ZONING, PLATTING & ADVISORY COMMITTEE (ZPAC) September 3, 2024 – Approved Meeting Minutes

Petition 24-24 James W. Filotto on Behalf of Oakland Avenue Storage, LLC

Re: Filotto Roofing – Site Plan

I ATE: I AWN BY: HE KEI BY: ___

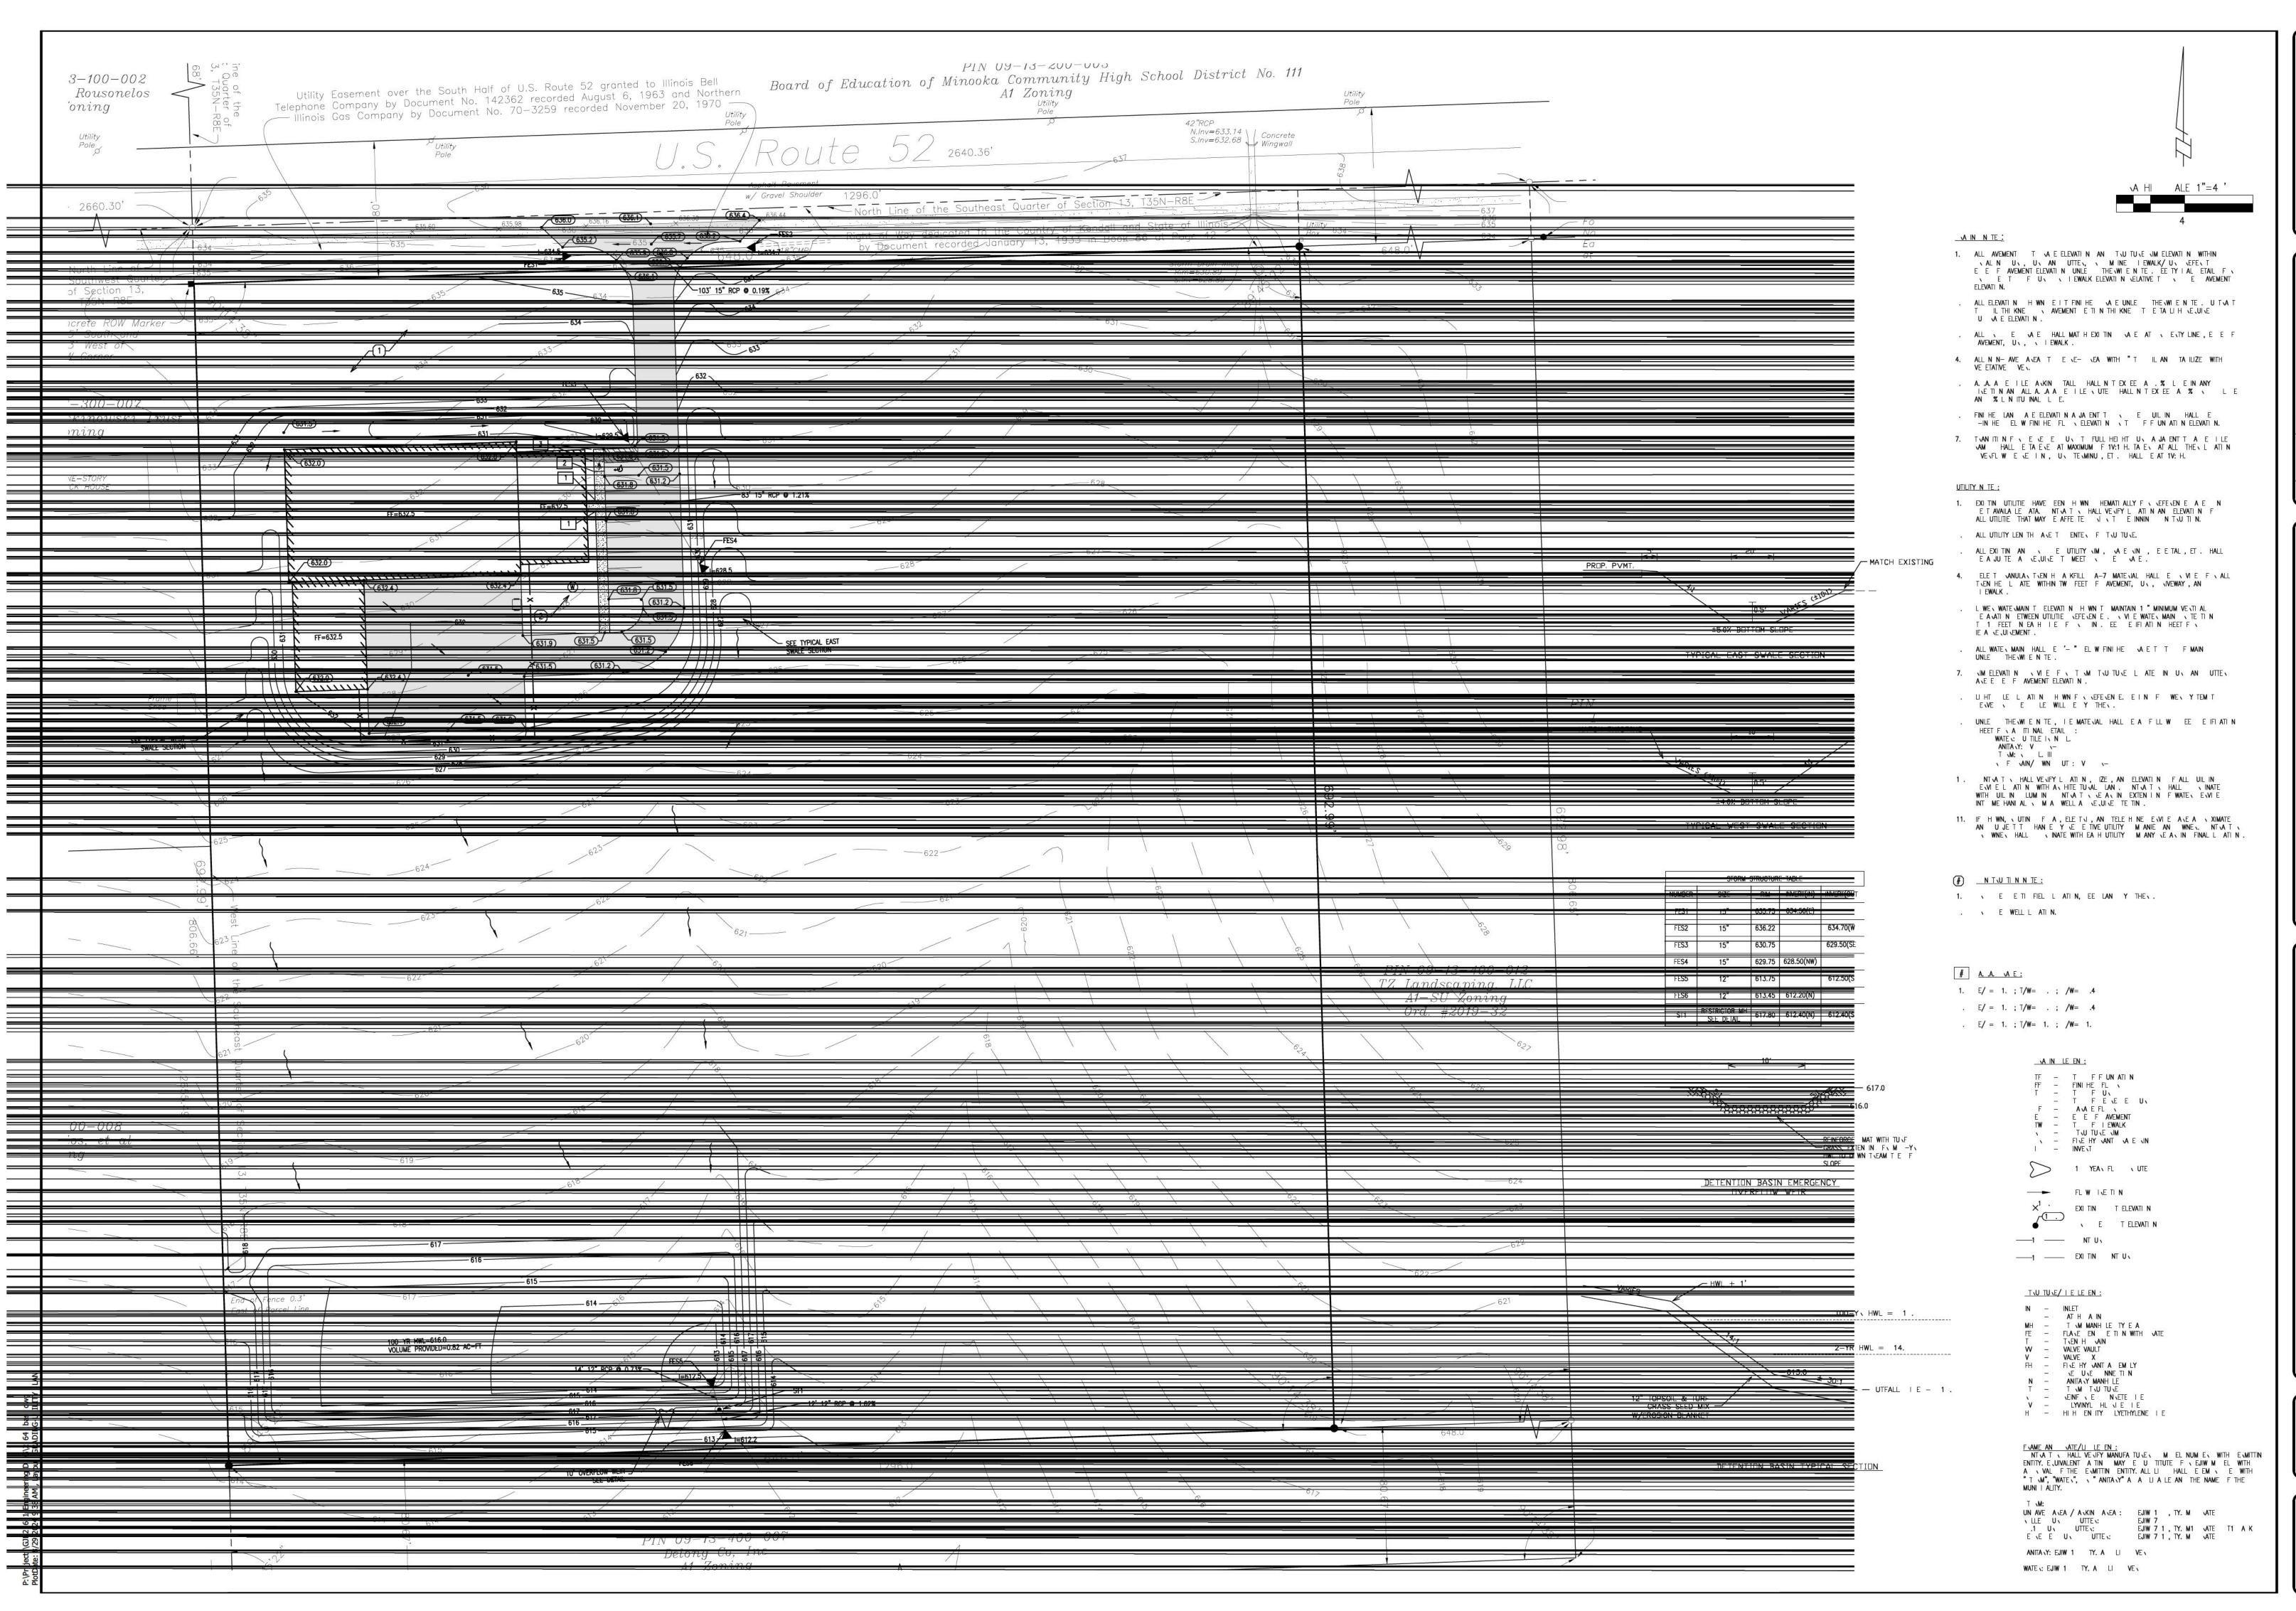
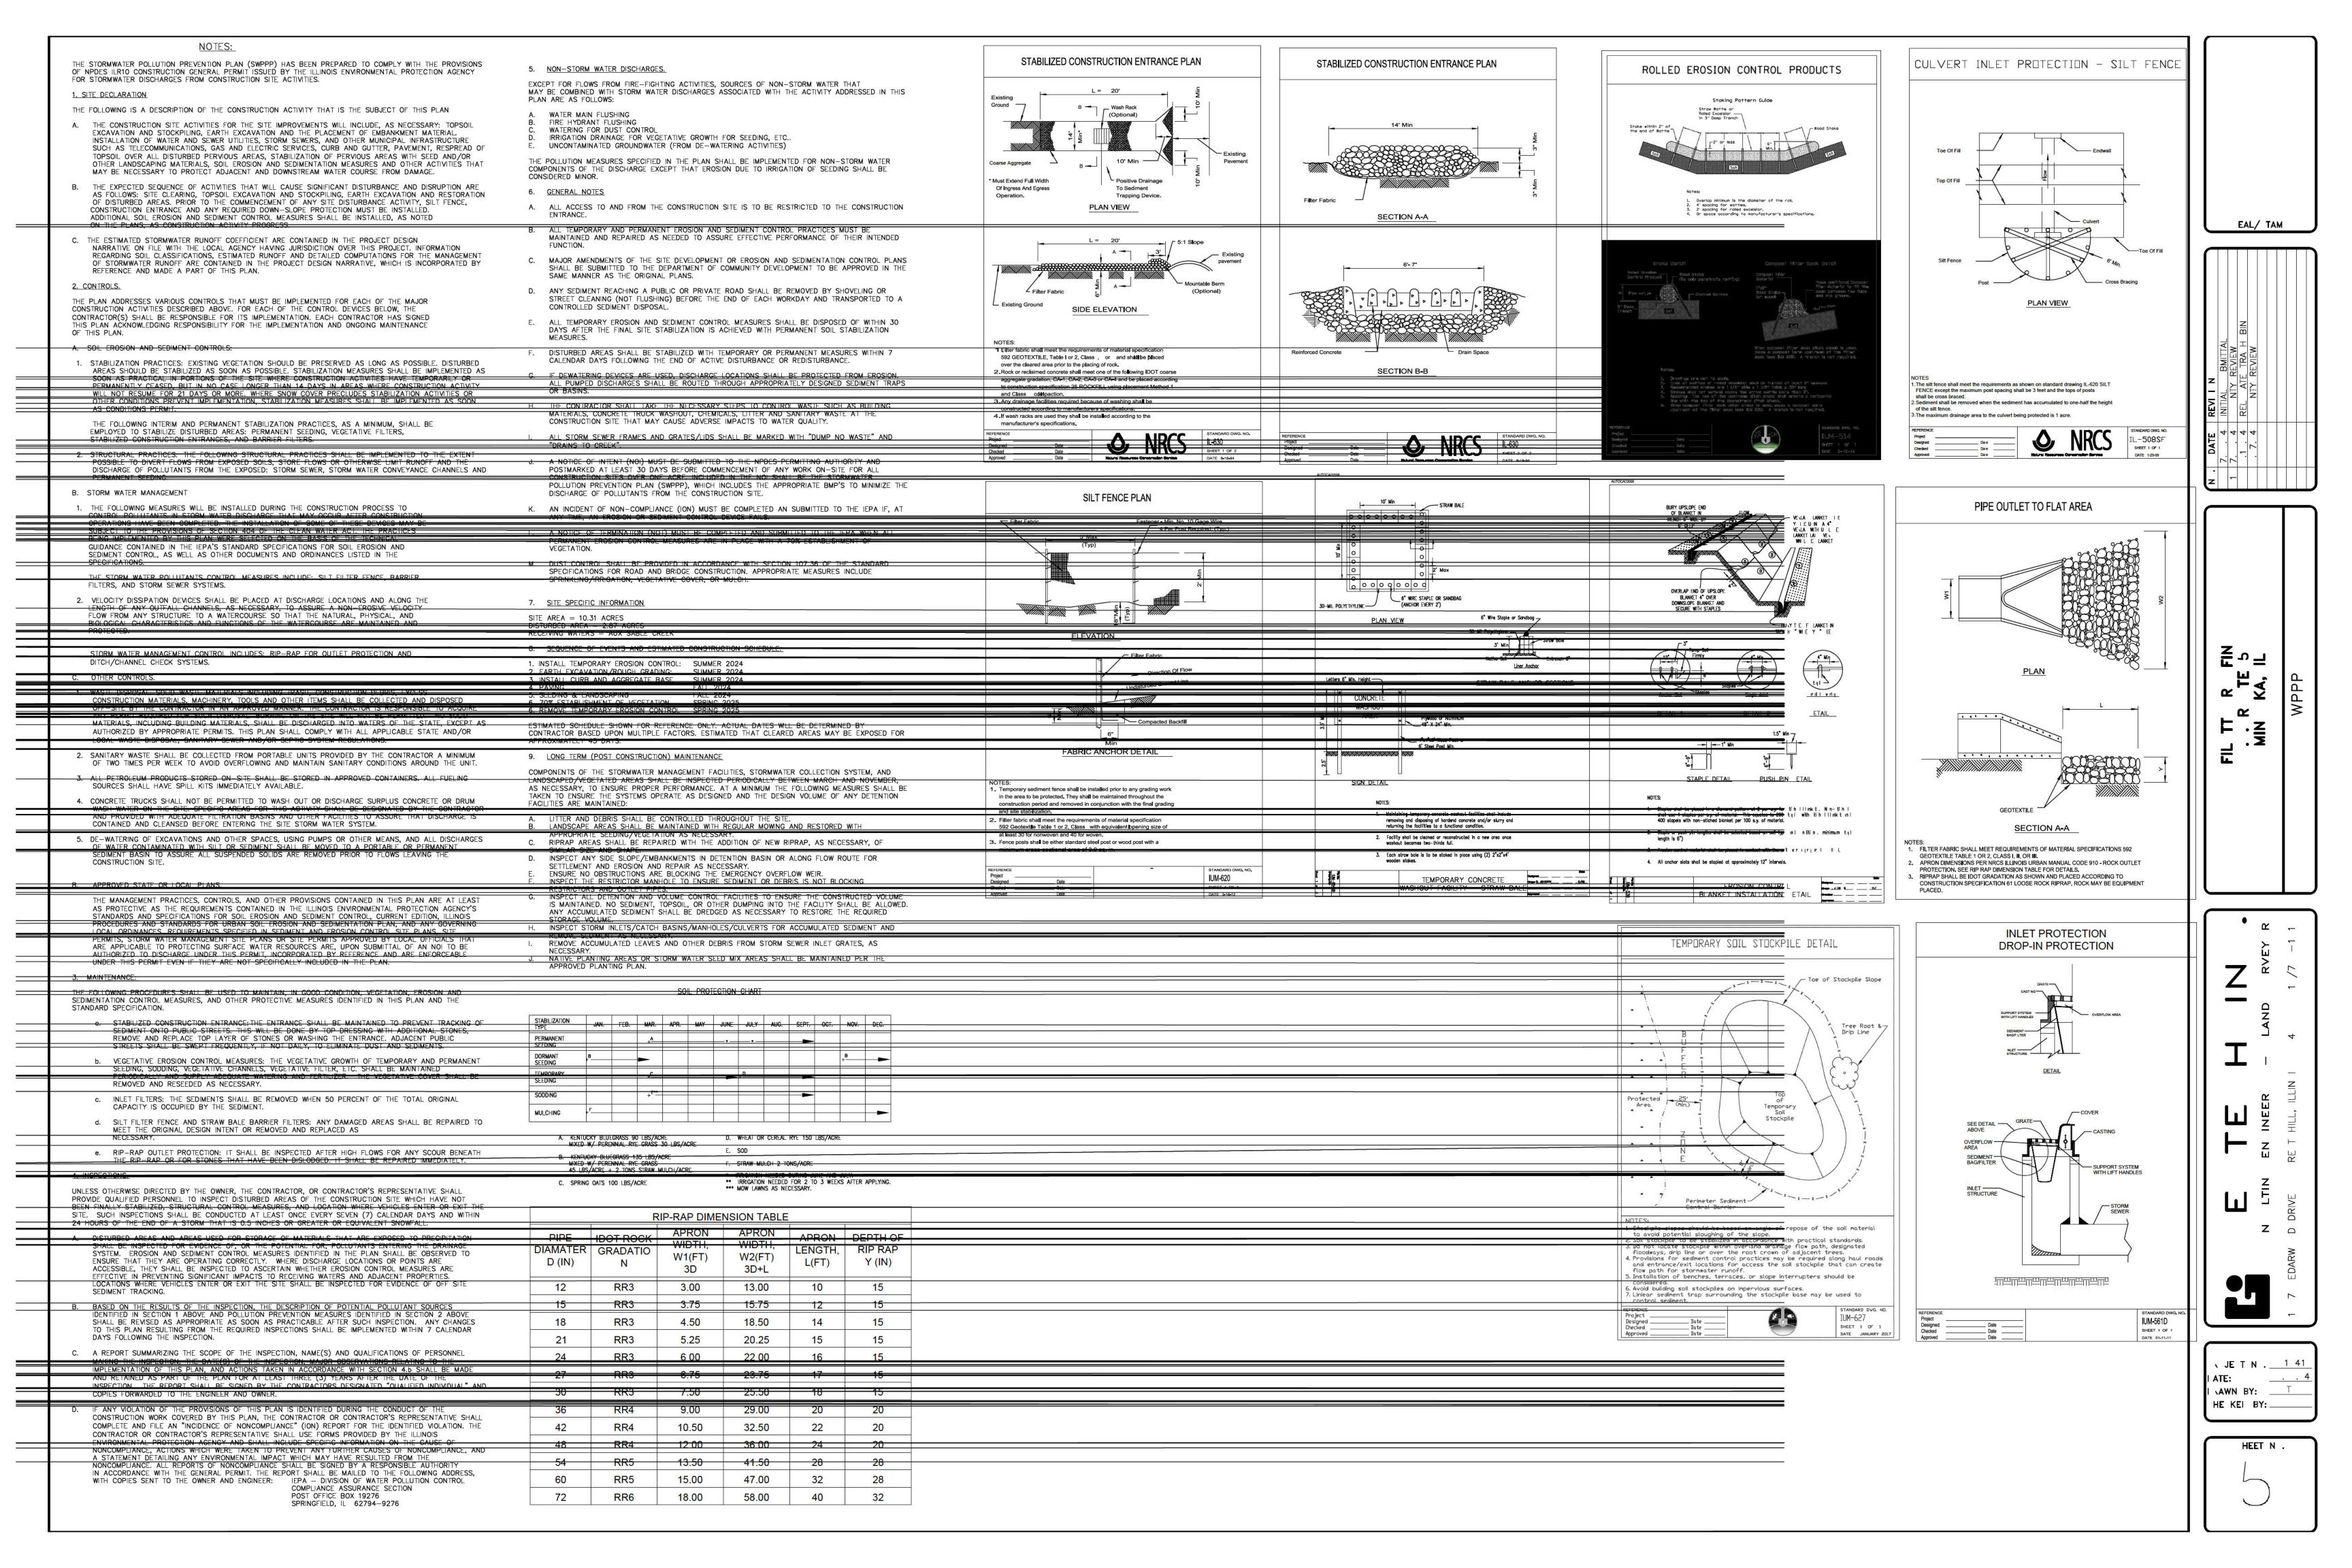
- 1. In the Stormwater Management Report, the Detention Tributary Area exhibit and detention calculations reflect the basin provides detention for the disturbed 2.87 acres, however, in proposed conditions the basin will accept runoff from an additional area between the proposed disturbance and possibly areas north of the proposed building. Please evaluate the overflow weir for this additional flow as to depth and velocity with the understanding overflow conditions will occur more frequently. The overflow weir calculations have been updated to include both the developed area and the undeveloped area that are both tributary to the proposed detention basin.

- 2. The weir coefficient is represented as two different values in the stormwater report. Verify the appropriate value. Also verify the weir length in the calculations matches the plans. **The stormwater calculations have been updated to reconcile the weir coefficients.**

- 3. Site Improvement Plans Please add dimensions to the restrictor manhole detail to verify the minimum 4" clearance will be met with the proposed top of wall elevation. Revise the grate type to maximize the overflow potential using a beehive type or "01" for EJIW products. The rim of the restrictor structure has been raised slightly to accommodate for the extra height of the beehive grate. Also, the restrictor structure detail has been updated to include dimensions to demonstrate that there will be adequate clearance for the top of the wall in the restrictor structure.

- 4. We understand the drainage swales along the east and west limits of the disturbed area are intended to capture flow from disturbed areas and route it to the stormwater basin. The definition of the swale is lacking in some areas. It is preferred that a typical minimum swale section be depicted that call out a minimum swale bottom side slope and depth to convey flows. Verify minimum depth with a channel capacity calculation. It is not necessary to revise all contours or include this additional area in the stormwater calculations, however we have no objection if that is done. Our primary concern is that the final field conditions will indicate clear capture and routing of the flows. Typical swale sections have been added to the Grading Plan. Also, Appendix 5 has been added to the Stormwater Report to demonstrate that the proposed swales have adequate capacity to convey the 100-year tributary flows to the detention basin.
